**ZONING AMENDMENT &
SUBDIVISION STAFF REPORT****Date: April 2, 2015****APPLICANT NAME**

Pender Ridge Subdivision

Rezoning from R-1, Single-Family Residential District, R-2, Two-Family Residential District, and B-2, Neighborhood Business District, to B-5, Office-Distribution District, to allow a heavy equipment storage facility and Subdivision approval to create four (4) legal lots of record.

SITE PLAN

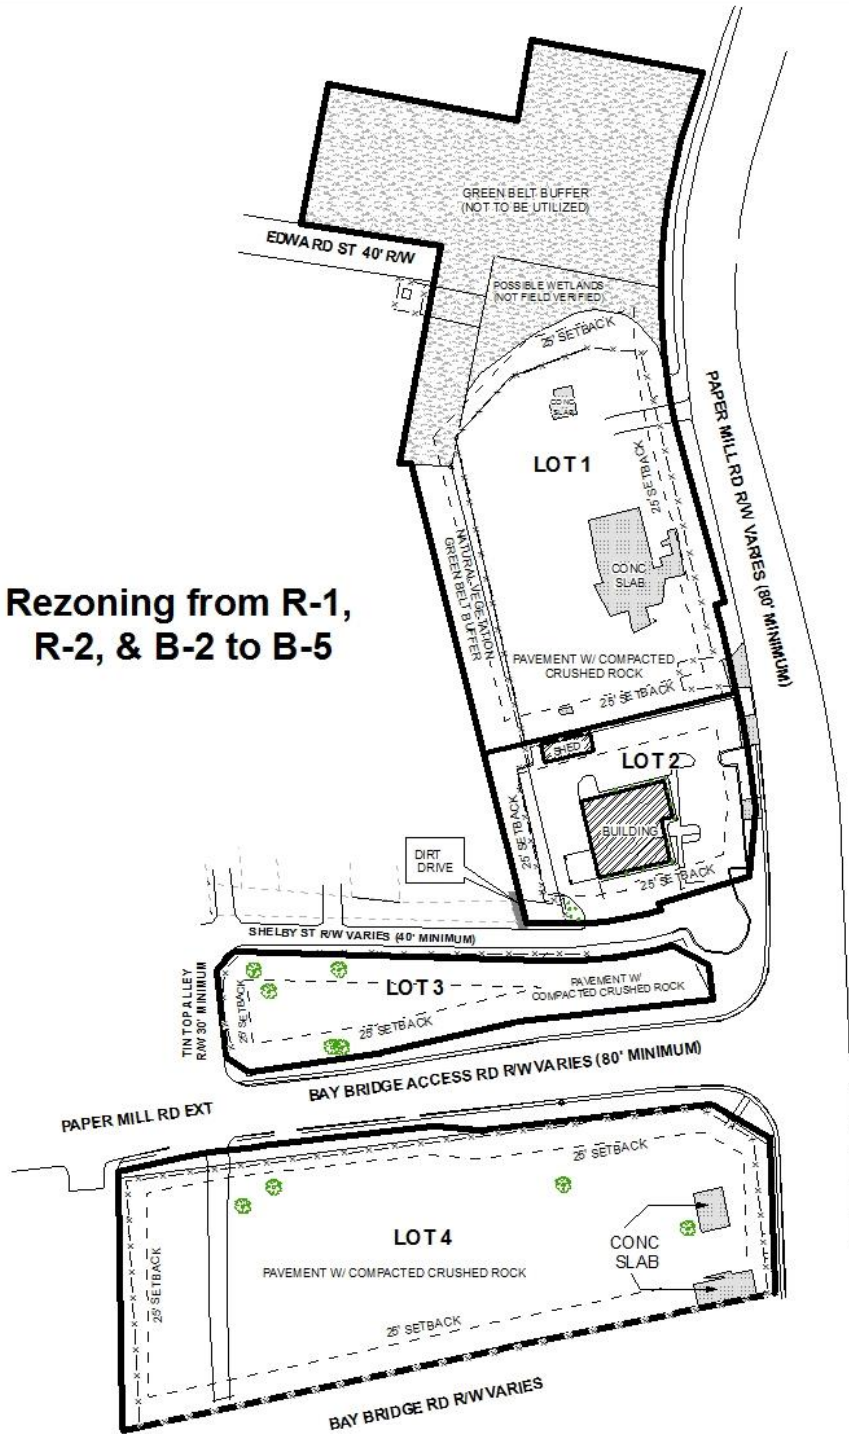
It should be pointed out that the site plan depicts crushed rock surfacing on the proposed Lots 1, 3, and 4. It appears that gravel surfacing was added to Lot 1 recently, without any permits or approvals, based upon a recent site visit initiated by a citizen complaint. Recent photos also show a new chain-link fence with barbed wire that also appears to have been installed without permits. Gravel surfacing is only allowed by right in I-1 and I-2 districts, and therefore, a variance from the Board of Zoning Adjustment will be required to allow the use of gravel for parking; otherwise, a paved parking surface will be required if the variance is not approved. A building permit for new fencing and approval by the Director of the Urban Development Department will be required for the barbed wire fencing.

The site plan depicts several large oak trees. Although dimensions are not depicted, the removal of any Live Oak tree greater than 24" will require a Tree Removal Permit.

No proposed sidewalks are illustrated on the site plan. Any future commercial use of the proposed lots will necessitate the installation of a sidewalk, or an application for a waiver may be submitted.

In accordance with the Subdivision Regulations, all 4 proposed lots are compliant with the minimum size requirements; however, Lots 3 and 4 will require a waiver of Section V.D.8. of the Subdivision Regulations due to frontage along multiple streets. The lot size is listed in acres on the plat and should be retained on the Final Plat, if approved.

As mentioned, the site has frontage along multiple streets: Bay Bridge and Paper Mill Roads, Paper Mill Road Extension, Edwards and Shelby Streets, Tin Top Aly, and Peace and Wiley Lanes. The right-of-way widths are depicted as variable; however, the minimum right-of-way should be depicted, per Section IV.A.2.d. of the Subdivision Regulations, and so that Staff can determine if the existing right-of-way widths are sufficient. It should be pointed out that the unopened right-of-way of Wiley Lane is not depicted but should be illustrated on the revised plat.

The 25' minimum building setback line is not illustrated on the plat and should be depicted along all road frontages and street stubs on the Final Plat, if approved.

It appears the applicant proposes a 30' minimum building setback in lieu of the required 25' minimum building setback. The 30' setback is depicted on the plat; however, given the fact that the site abuts multiple streets, this setback does not appear along all road frontages. As such, the Final Plat should be revised to illustrate a minimum of at least a 25' minimum building setback line along all road frontages, to include Edwards Street and Wiley Lane, if approved. The minimum right-of-way width of Peace Lane, which is located along the western lot line of the proposed Lot 4, should also be illustrated on the Final Plat – with the provision of dedication sufficient to provide 30' from centerline, if necessary - if approved.

A 50' Plains Pipeline L.P easement is depicted within the eastern portion of the proposed Lot 1 along Paper Mill Road. If approved, a note should be placed on the Final Plat stating that no permanent structure(s) can be placed or constructed within any easement.

- 1) Dedication, sufficient to provide 30', as measured from the centerline of Tip Top Aly and Shelby Street for Lots 2 and 3;*
- 2) Revision of the lot size information and 30' minimum building setback line to reflect dedication;*

- 3) Placement of a note on the Final Plat stating: (No permanent structure(s) can be placed or constructed in any easement);*
- 4) Retention of the lot size information and 25' minimum building setback line on the Final Plat;*

- 5) Placement of a note on the Final Plat stating: Lot 1 should be denied access to Edwards Street and the unopened right-of-way of Wiley Lane and be limited to the existing two curb-cuts. Lot 2 should be limited to the existing curb-cuts. Lot 3 should be denied access to Shelby Street and be limited to two curb-cuts. Lot 4 should be denied access to Paper Mill Road and Peace Lane and be limited to the existing curb-cuts. The size, design and location of new curb-cuts and any changes to the existing curb-cuts are to be approved by Traffic Engineering (and ALDOT, where appropriate) and conform to AASHTO standards;*
